ULNRC- 04558

**DOCKET NUMBER 50-483
CALLAWAY PLANT
UNION ELECTRIC COMPANY
RESPONSE TO REQUEST FOR ADDITIONAL INFORMATION
ON REVISION TO TECHNICAL SPECIFICATION 5.5.9
"STEAM GENERATOR (SG) TUBE SURVEILLANCE PROGRAM"**

**REQUEST FOR ADDITIONAL INFORMATION
REVIEW OF THE CALLAWAY PLANT APPLICATION
FOR REVISION TO TECHNICAL SPECIFICATION 3/4.4
TAC NUMBER: MB1214**

Figure R20-1, Sample: 120196-03
ID pit: 1

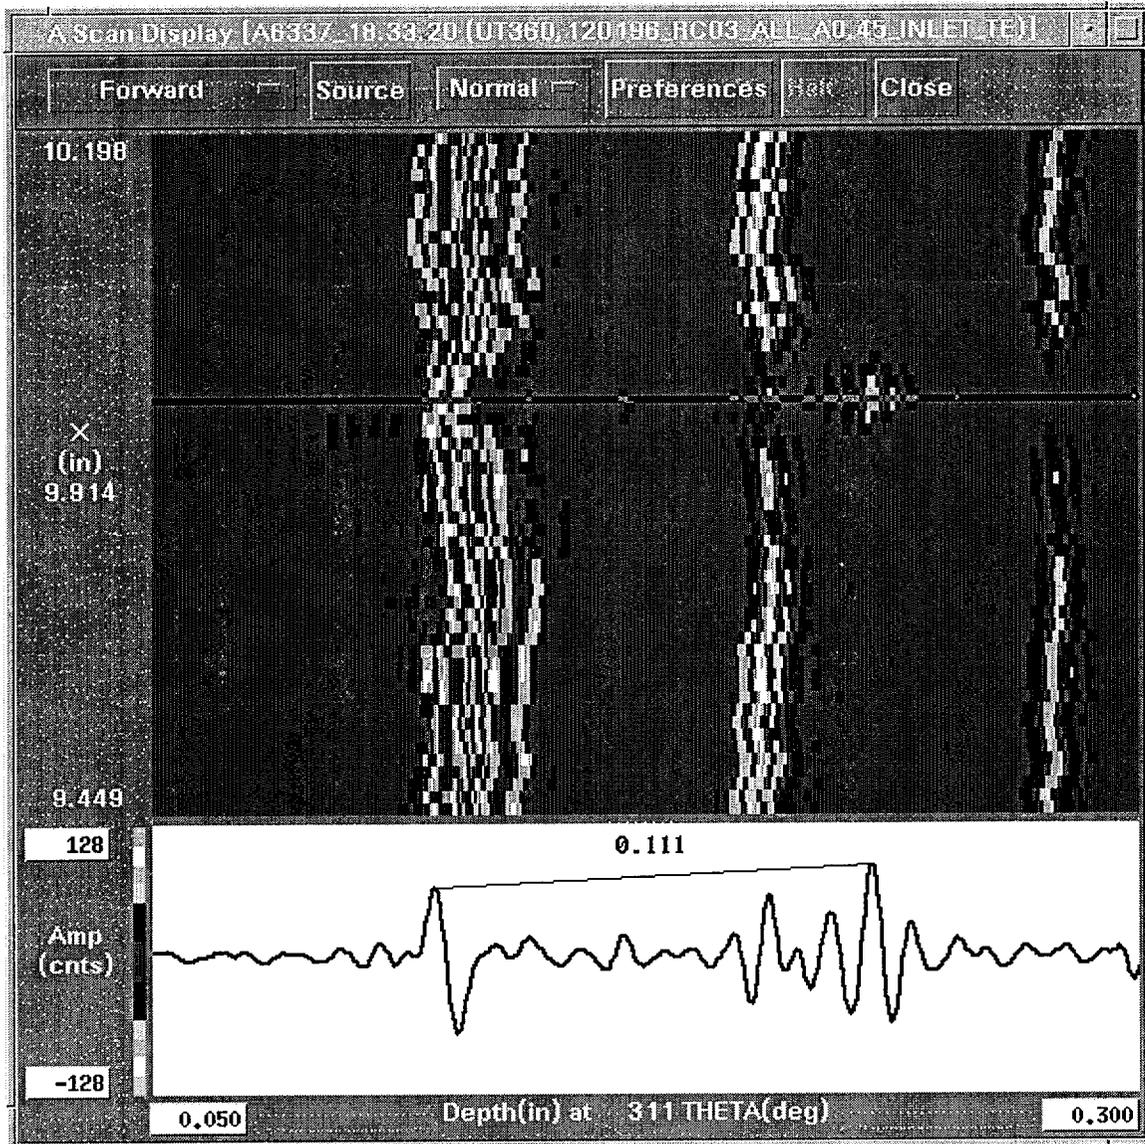
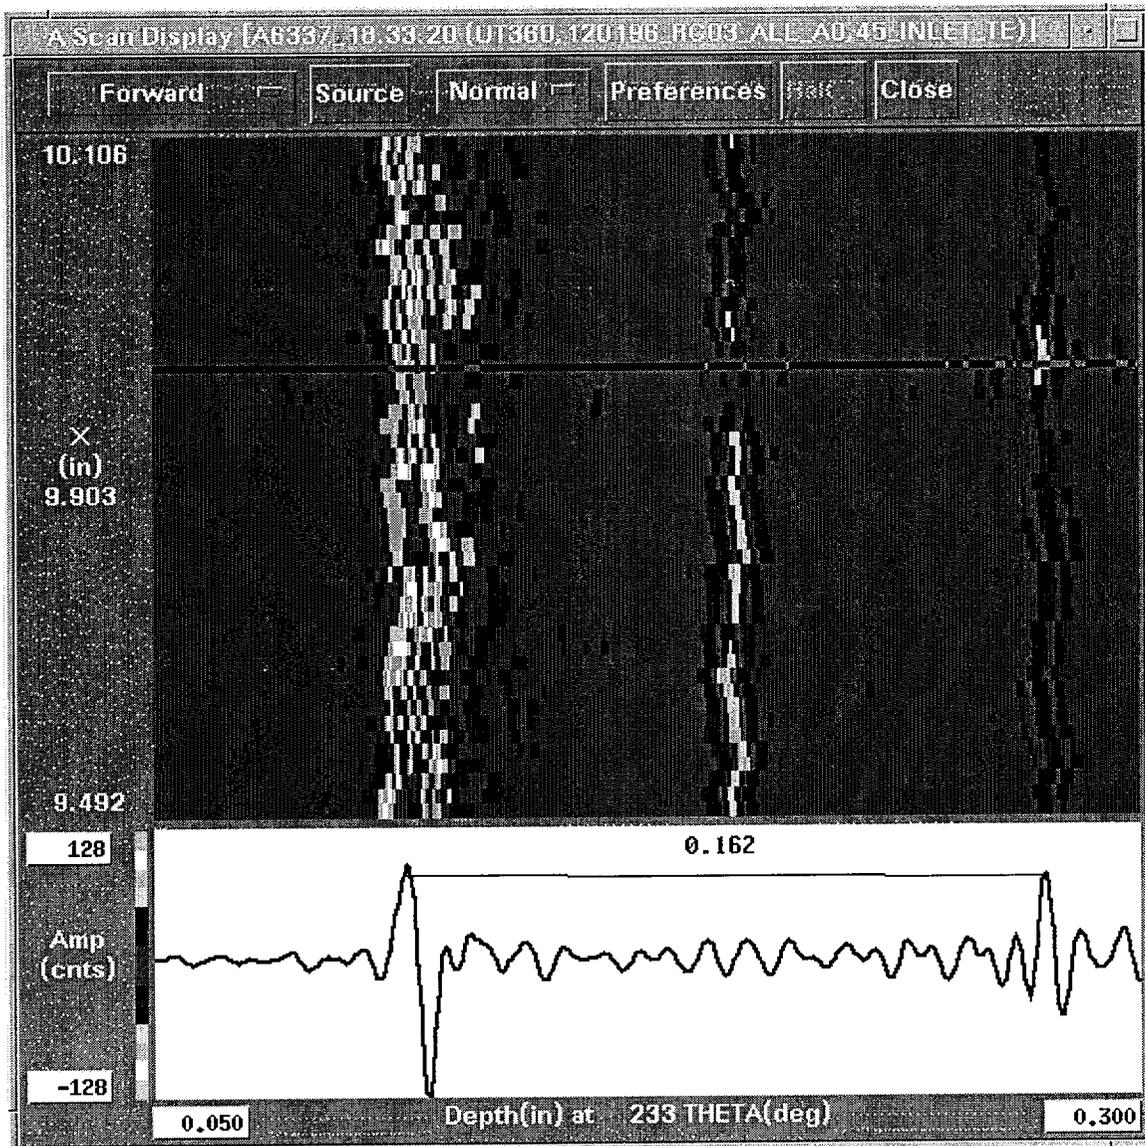
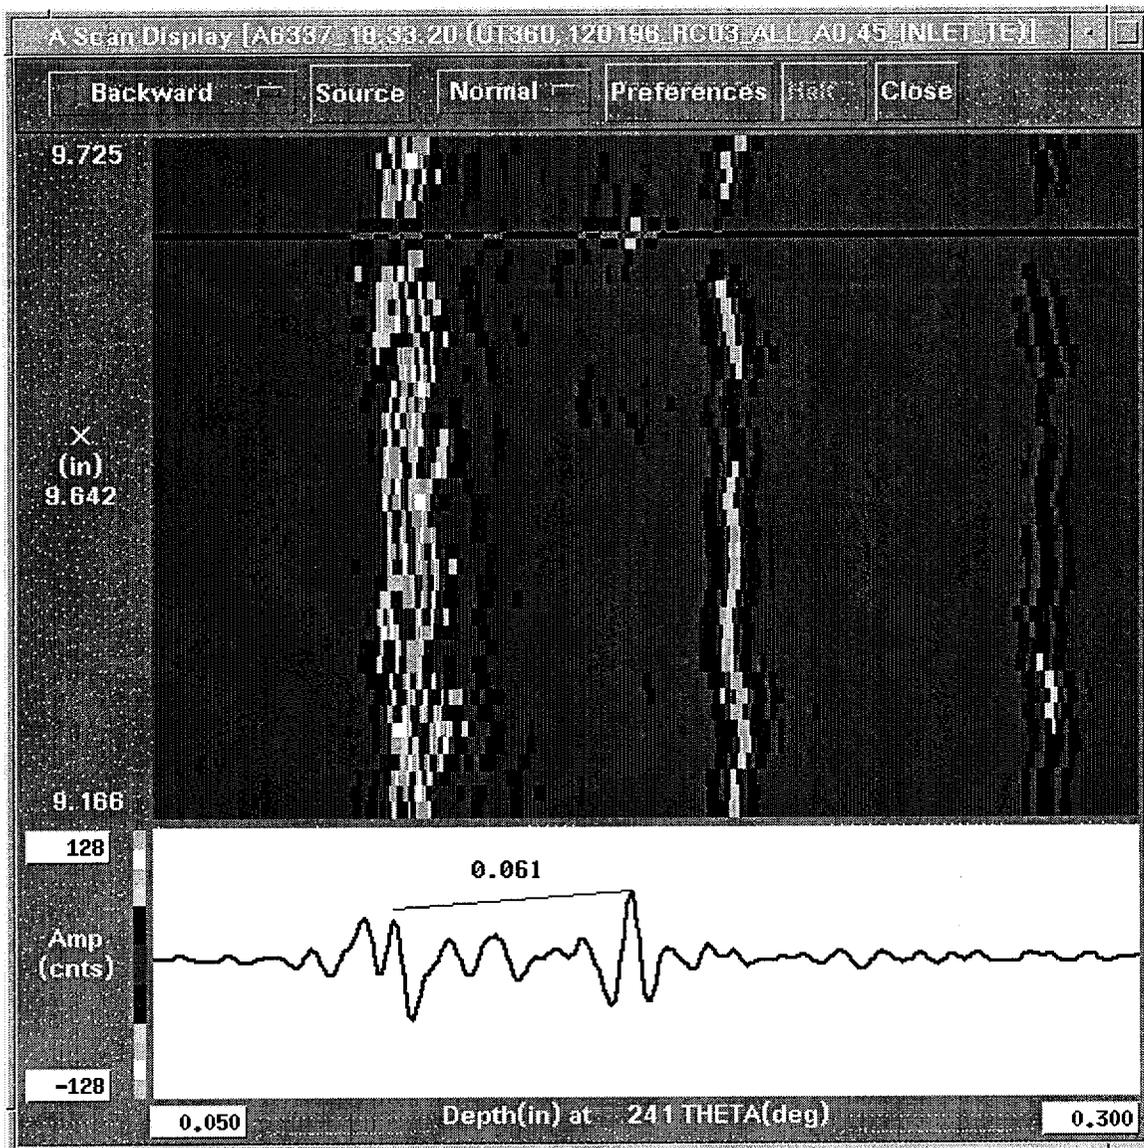
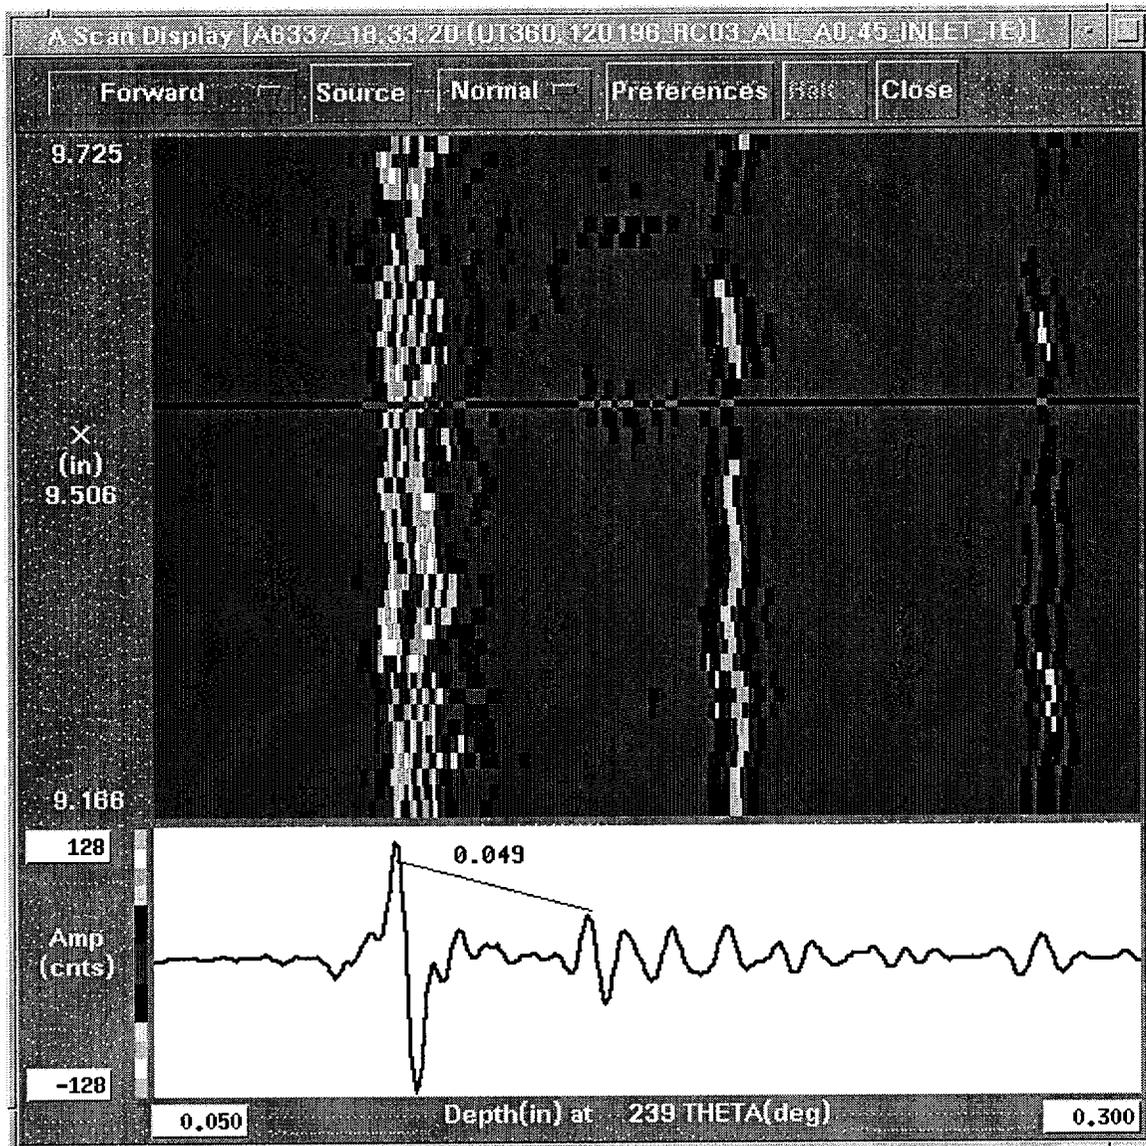
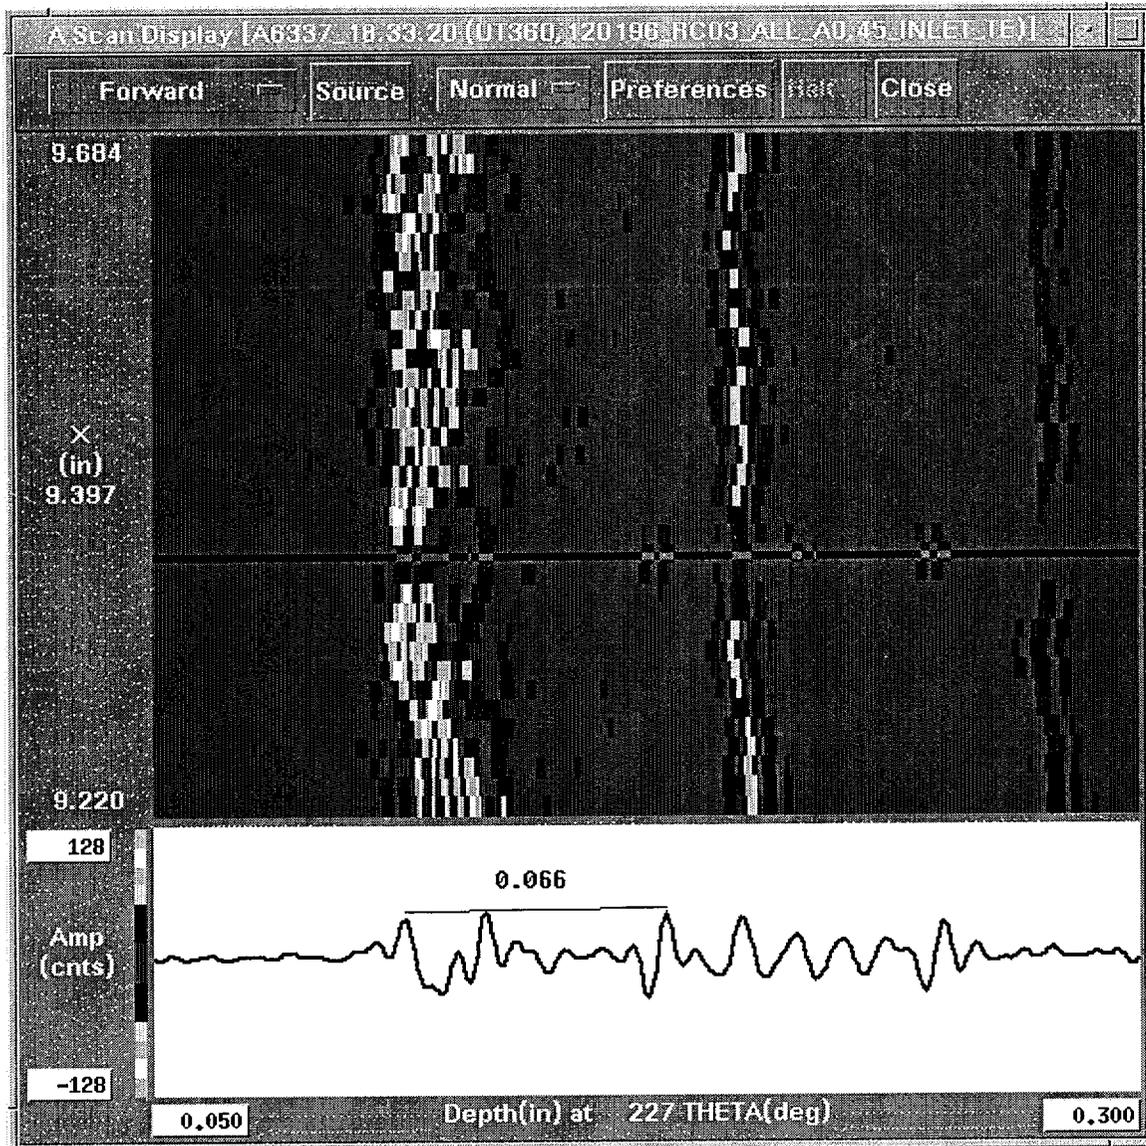
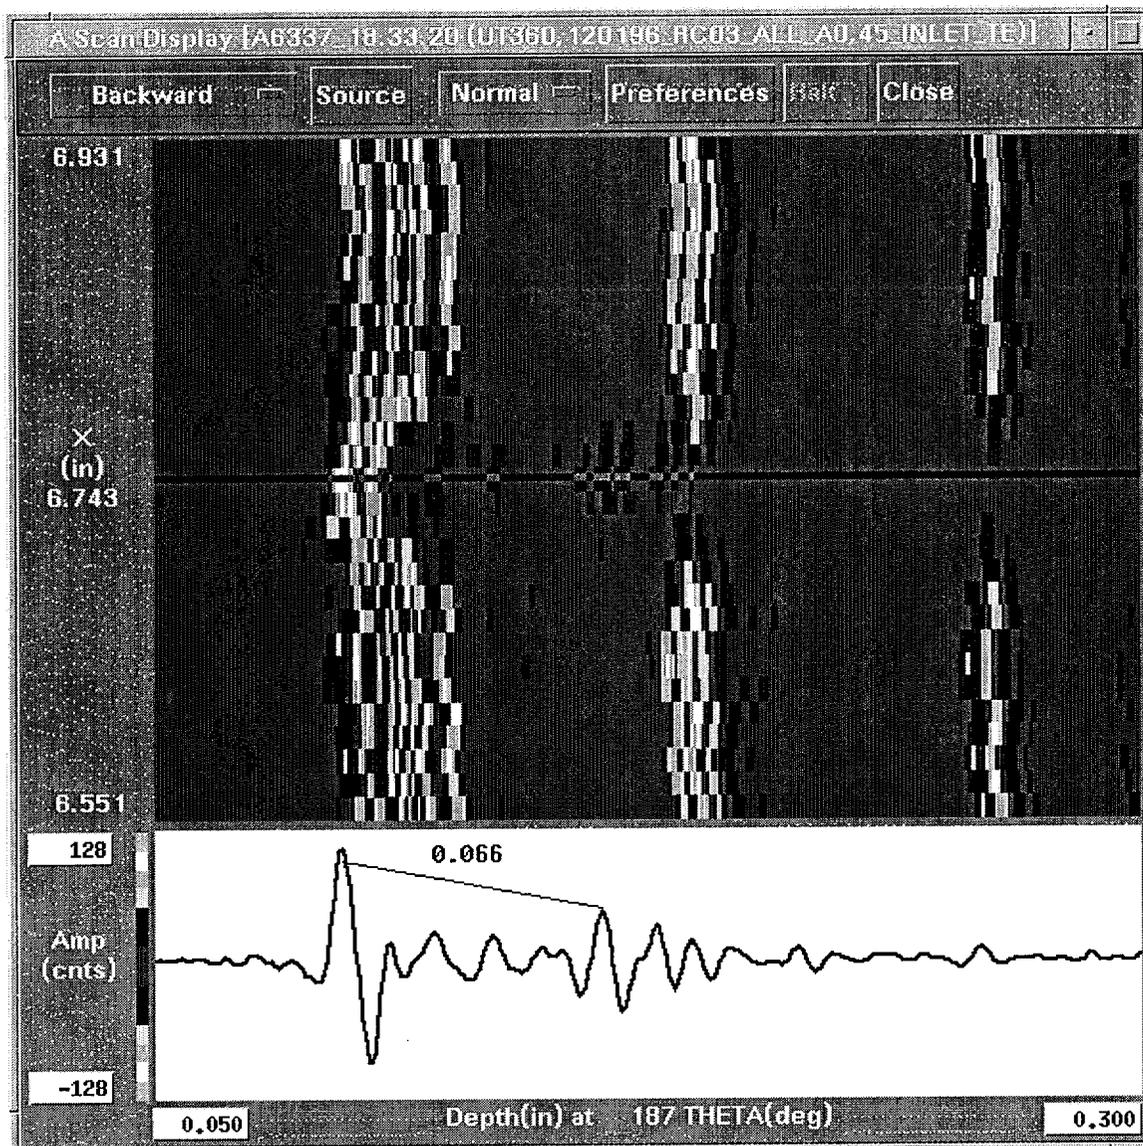
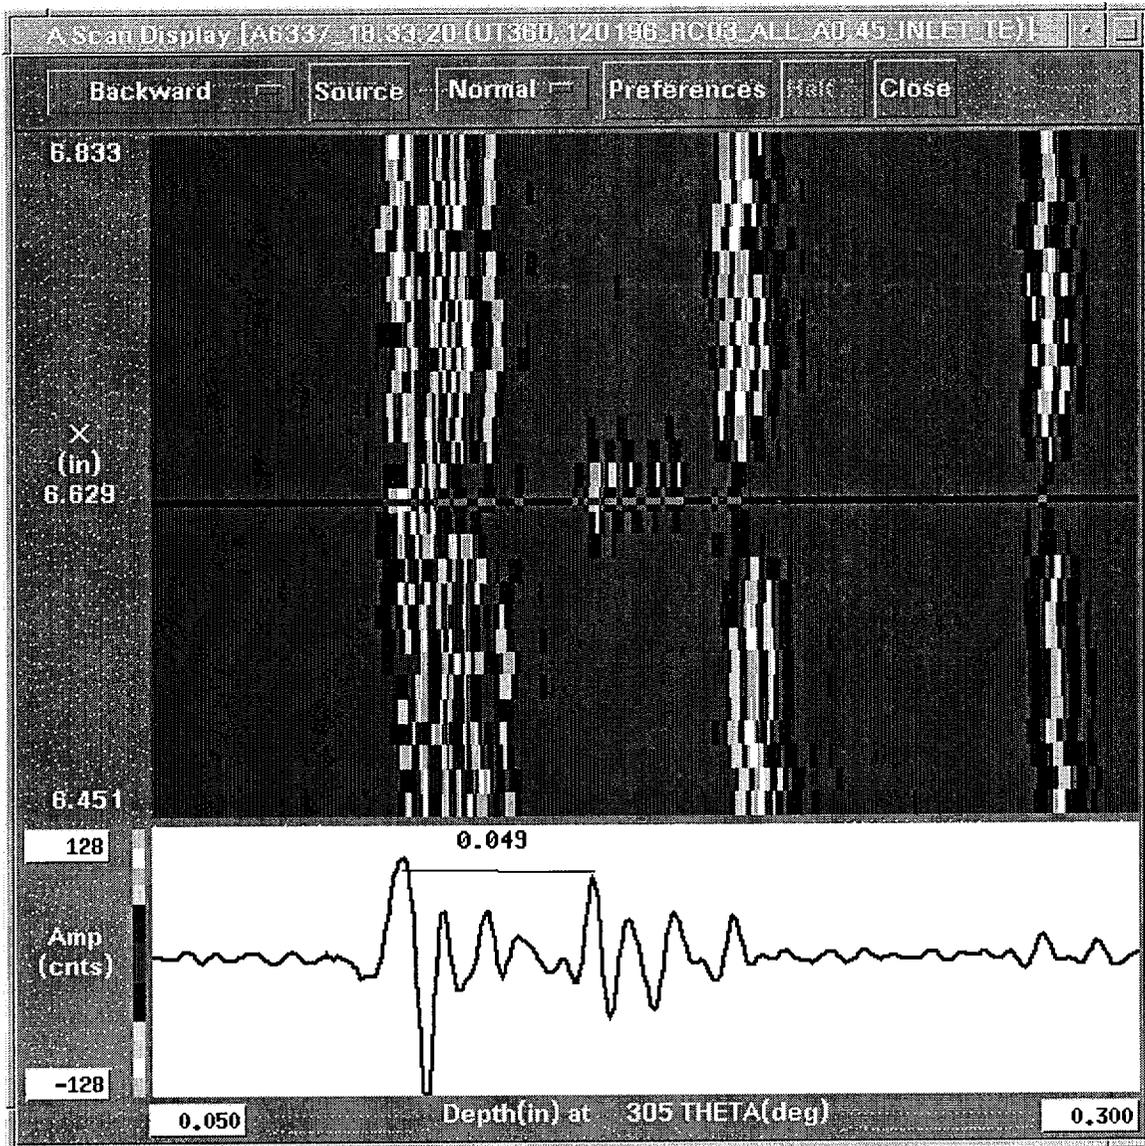
RAI # 20. The report states that because ID pits are conservatively assumed to be 100% through the sleeve, no depth sizing is required. However, the report states that UT can detect the ID pits. The report states that "ID pits with a depth greater than one wavelength" which is approximately 0.006 inches for a 10MHz transducer and a 0.058 inch/ μ s speed of sound in water can be detected because there should be at least two distinct surface reflections. Please provide UT data to support your ability to detect ID pits. (Page 11-45, BAW-10219P, Rev. 4)

The quality control inspector performing the replicant measurements indicated that the values for depth were accurate to +/- 0.002 inch.

UT estimated depth: $(0.111 * 0.058/0.233) = 0.028$

UT estimated depth: $(0.162 * 0.058/0.233) = 0.040$

UT estimated depth: $(0.061 * 0.058 / 0.233) = 0.015$
